April 16, 2021

Subject: Comments on CDFW Draft Instream Flow Recommendations for the Lower Ventura River and Coyote Creek

Subject: Peer Review of and Comments on the California Department of Fish and Wildlife Draft Instream Flow Recommendations – Lower Ventura River and Coyote Creek and Relevant Documents

Figure 1

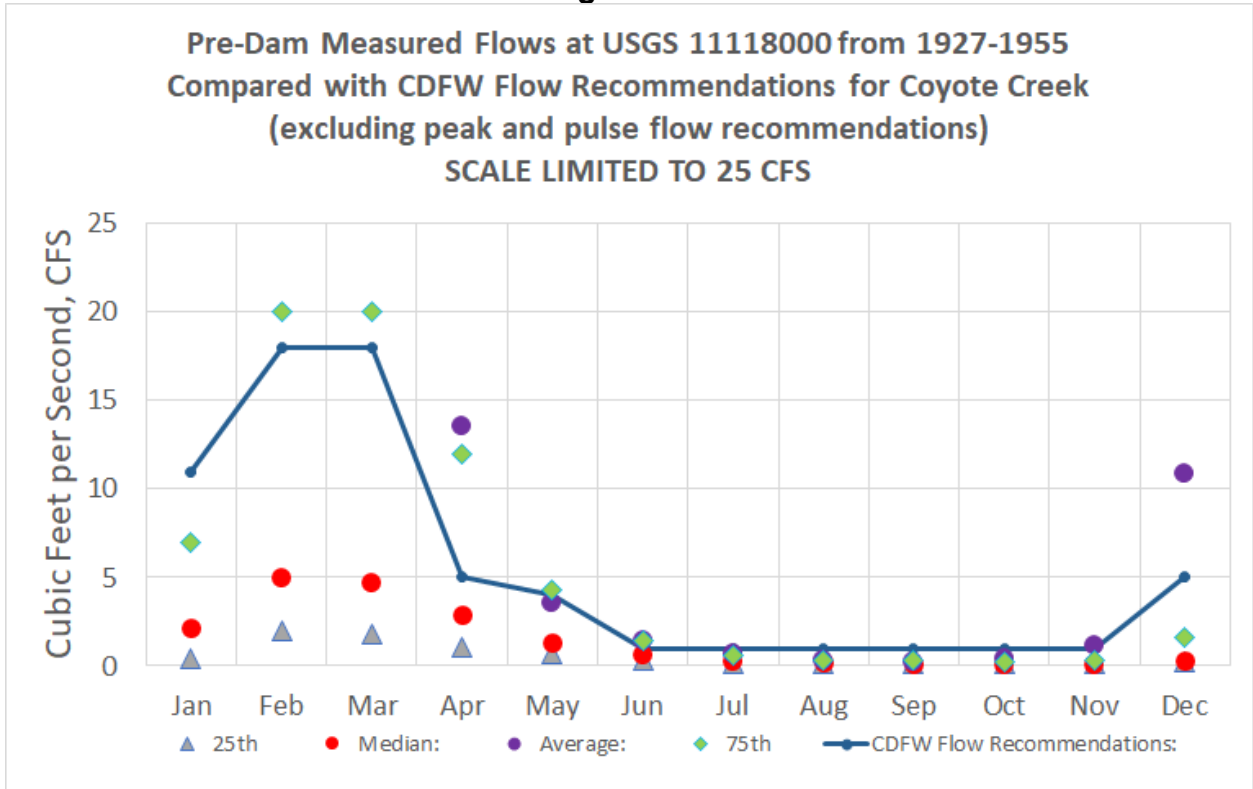
Statistical analyses of pre-dam gage data along Coyote Creek (Attachment 1) shows that CDFW flow recommendations for Ecosystem Baseflows exceed pre-dam median flows in all months, and significantly exceed the pre-dam median flows in December through May. This means that over 50 percent of the time, the unobstructed pre-dam flows in these months would not have met the CDFW Ecosystem Baseflow recommendations. The CDFW flow recommendations state that “when reservoir inflows naturally fall below the flow recommendations, releases should be equal to inflows to the reservoir.” However, there are no existing gages currently in operation to measure real-time tributary inflows to the reservoir. All gages have been damaged by heavy sediment loads following the 2017 Thomas Fire.

Figure 1 (Coyote Creek) shows that CDFW Draft Instream Flow Recommendations exceed historical pre-dam median flows in all months, and significantly exceed the historical median flows in December through May.

Figure 2

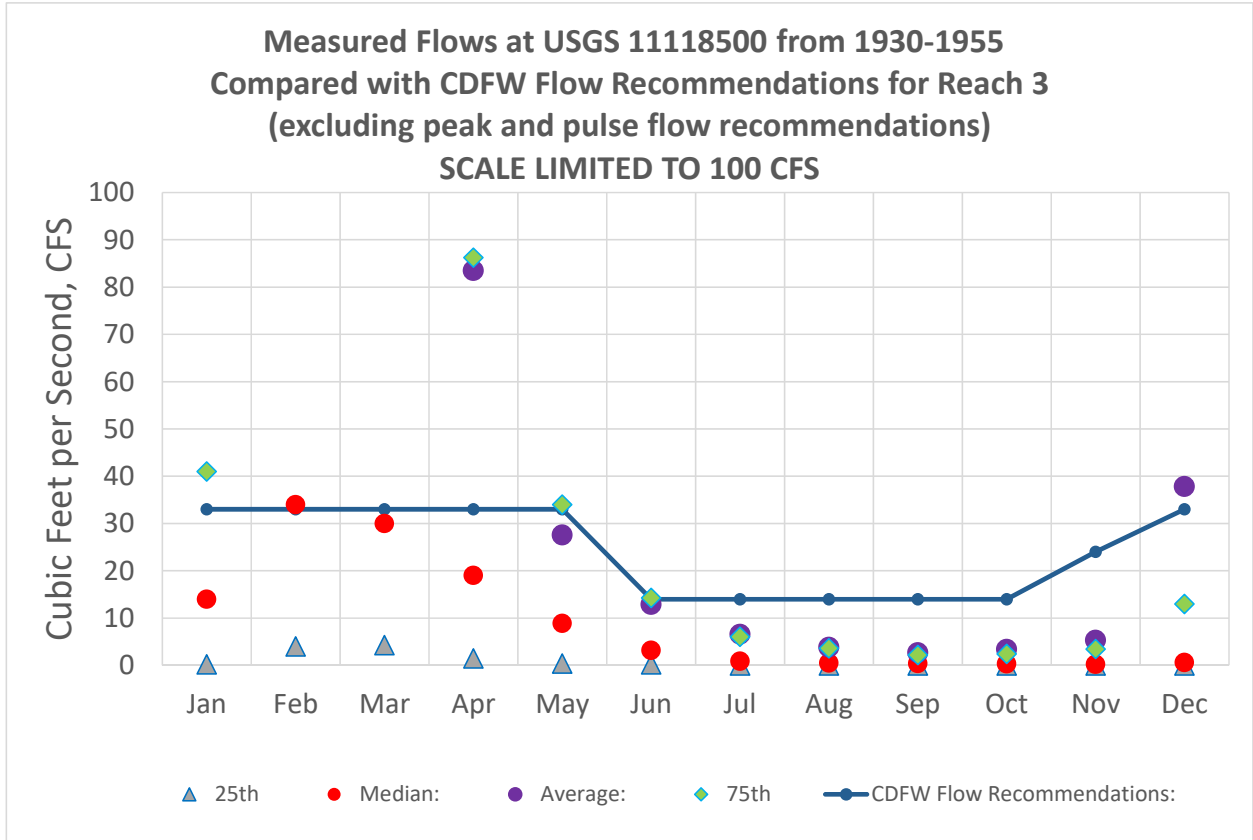
Casitas is concerned about the water supply impacts of Lower Ventura River flow recommendations. The CDFW Instream Flow Recommendations exceed historical (pre-Casitas Dam and pre-Robles Diversion) median flows in nearly all months, and significantly exceed historical median flows in April through January (Attachment 1).

Figure 2 (Reach 3 of Lower Ventura River) shows that CDFW Draft Instream Flow Recommendations exceed historical pre-dam and pre-diversion median flows in nearly all months, and significantly exceed historical median flows in April through January.

Figure 3

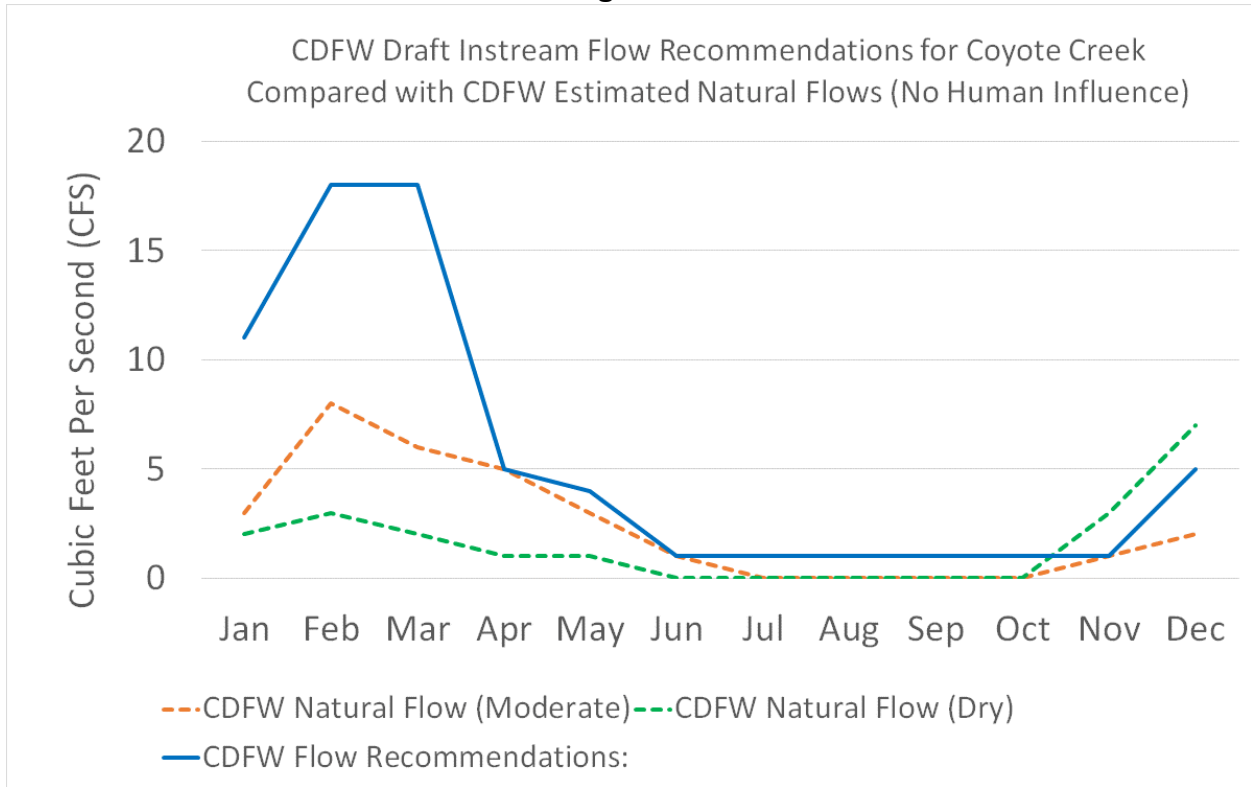
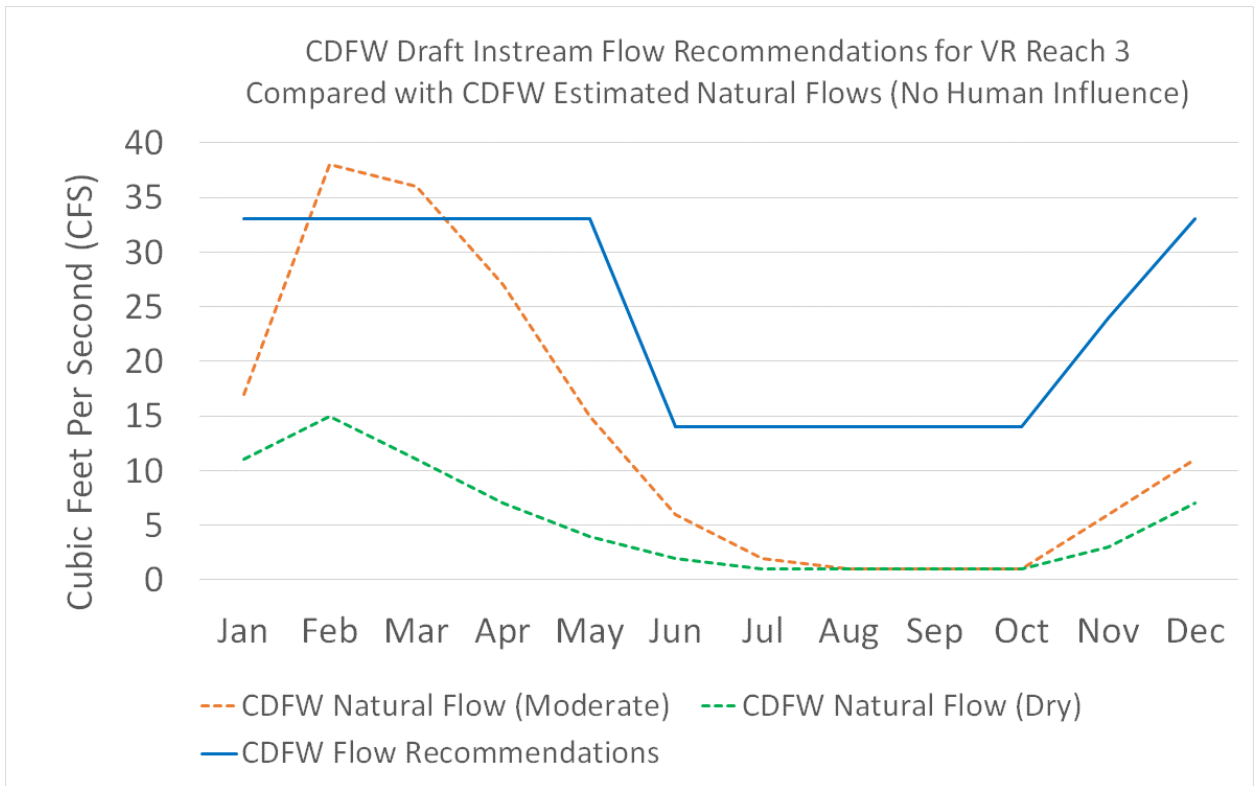
Table 1 the CDFW *Instream Flow Regime Criteria on a Watershed Scale - Ventura River* dated May 2020 presents estimated natural flows which “would be expected with no human influence”. The CDFW estimated natural flows are compared with the Draft Instream Flow Recommendations for Coyote Creek and Lower Ventura River in Figures 3 and 4. As shown, the flow recommendations exceed the moderate (median) dry natural flows that would be expected with no human influence. This means there would be no water supply available many months, particularly with more frequent dry conditions expected to occur with climate change.
